# ENVIRONMENTAL REVIEW TEAM REPORT

**TRAVEL  
CENTER**

**SOUTHBURY,  
CONNECTICUT**

Environmental Review Team Report

**PRELIMINARY**  
**SITE PLAN**

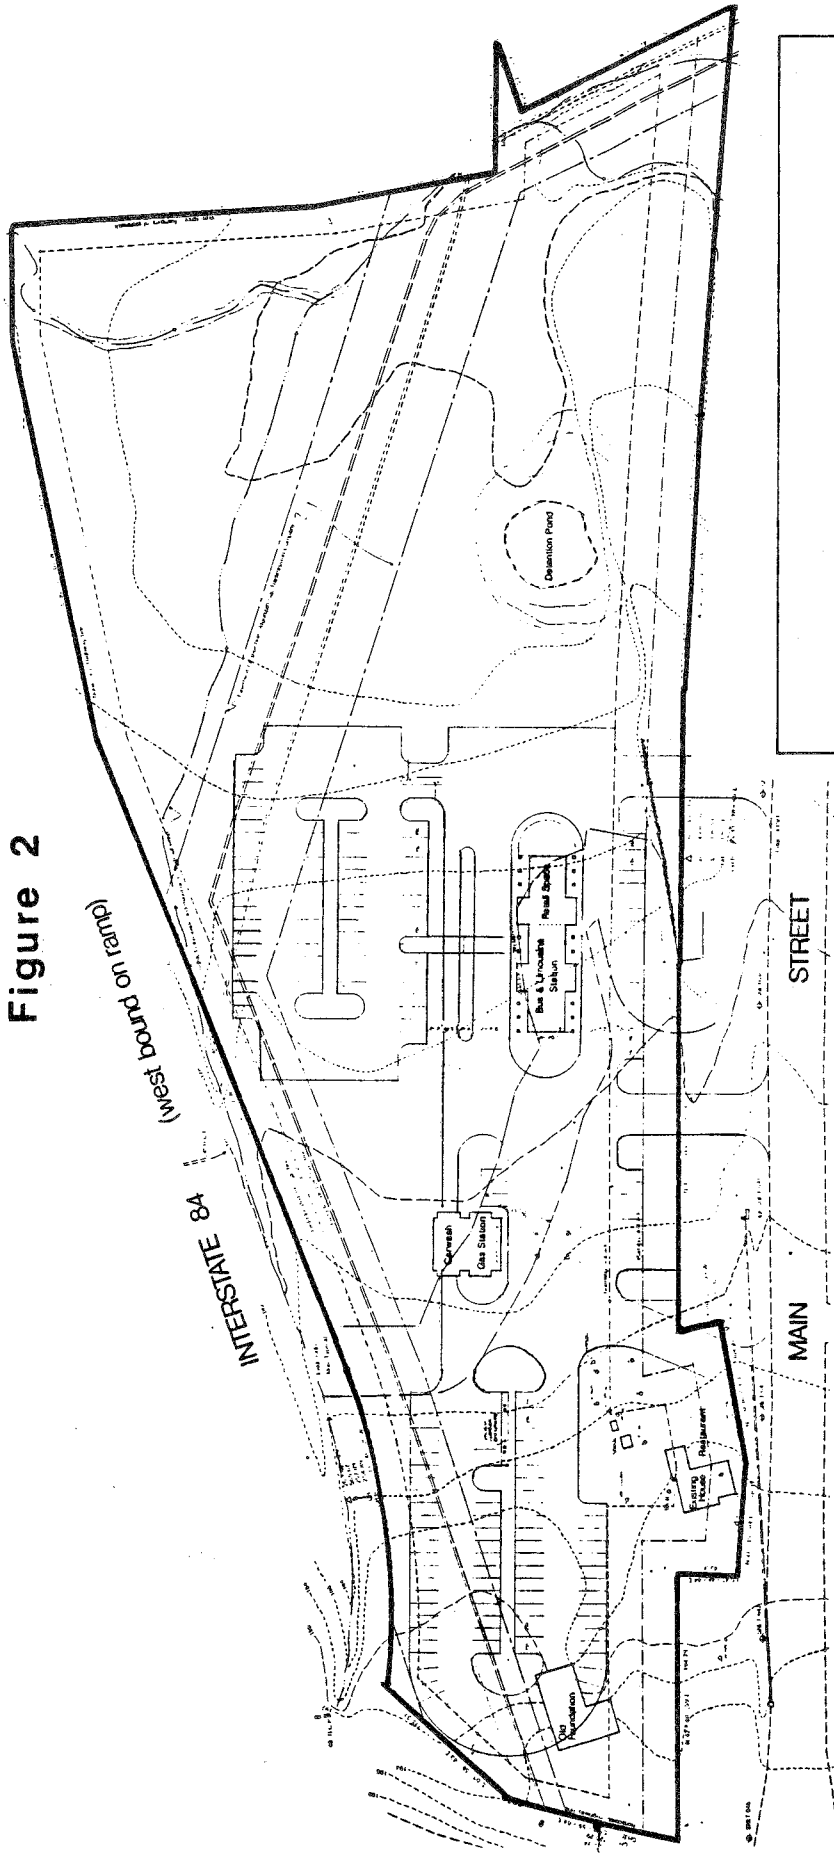
The proposed travel center would encompass three separate buildings: (1) a bus and limousine terminal, with retail space; (2) a gas station/convenience store, with an attached car wash; and (3) a restaurant. Over 200 long-term and short-term parking spaces will be constructed. The site will be served by on-site wells and septic systems. A detention pond is also proposed (Figure 2).

As proposed on the latest drawings, approximately 70 percent of the development site will be on inland wetlands or immediately adjacent to them.

It is not known at this time how much filling of inland wetlands will be proposed. At a minimum, sediment barriers should be properly installed between the wetlands and all disturbed areas.

to locate the pond on upland soils. It seems likely that this could require reconfiguration of buildings and parking areas within the site resulting in the possible reduction of development on the site. Close examination of the 18-inch pipe under Main Street South is also warranted.

Figure 8

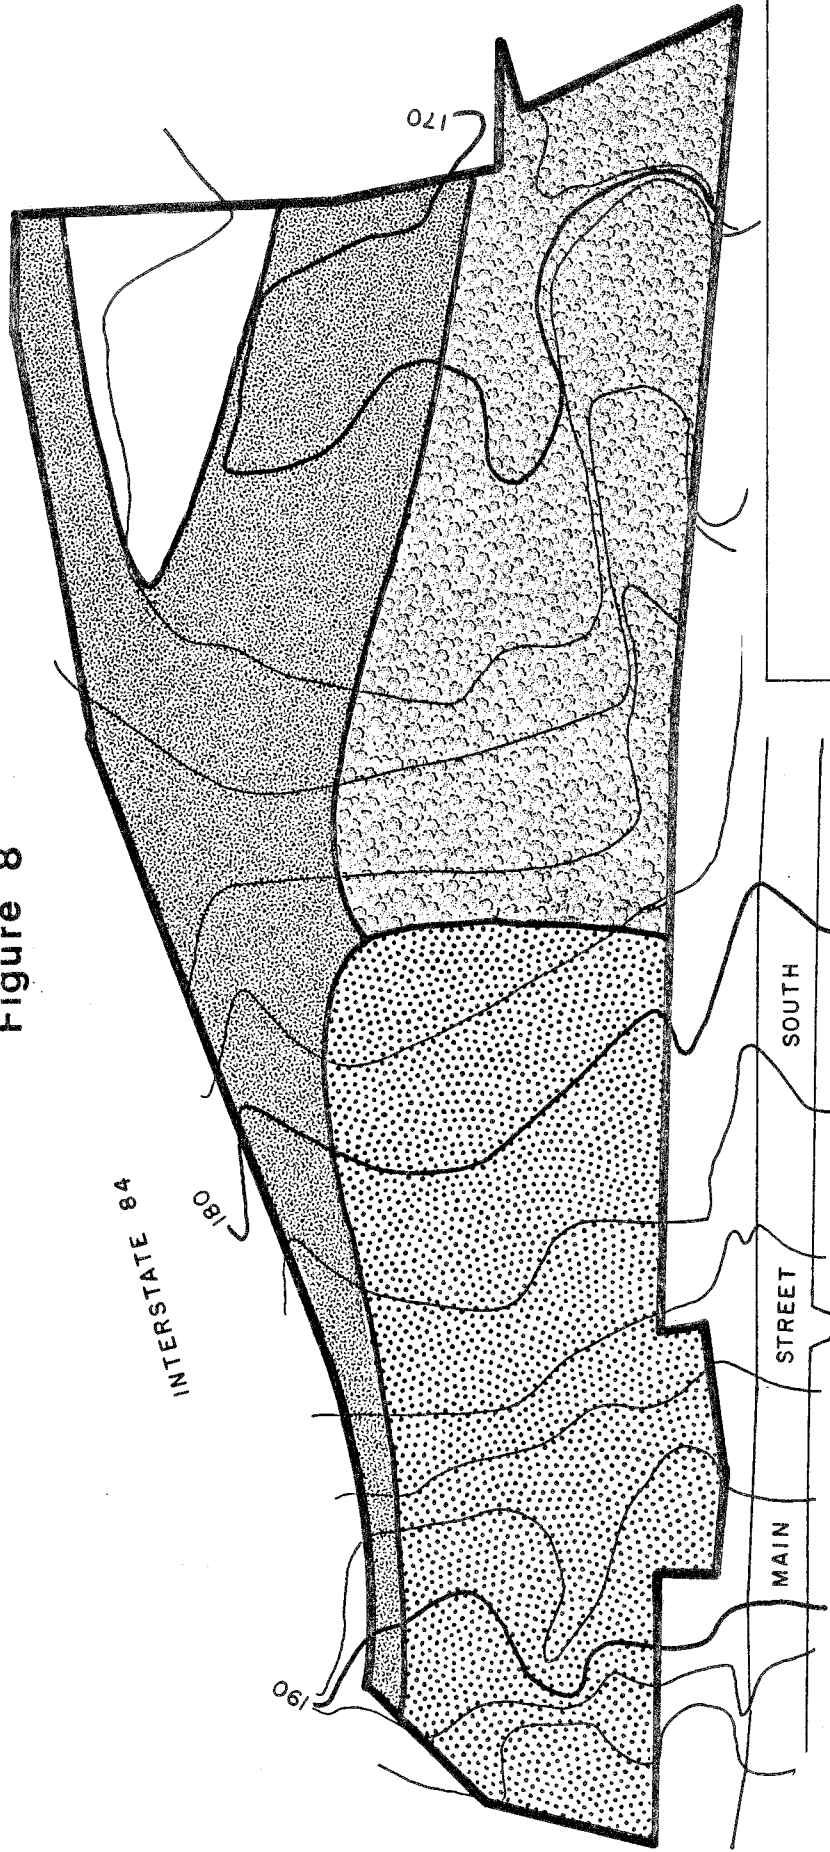
If properly sited, however, a detention pond might serve to divert contaminants and sediment from the least disturbed section of the wetland Zone 3. It is suggested that the detention pond not be located in Zone 3, since it would simply form another disturbance to the wetland. If a pond is constructed, the material removed must be disposed of properly and away from wetland areas. Increased runoff will also affect the distribution of herbaceous plants in the wetland, but is unlikely to harm the woody species.
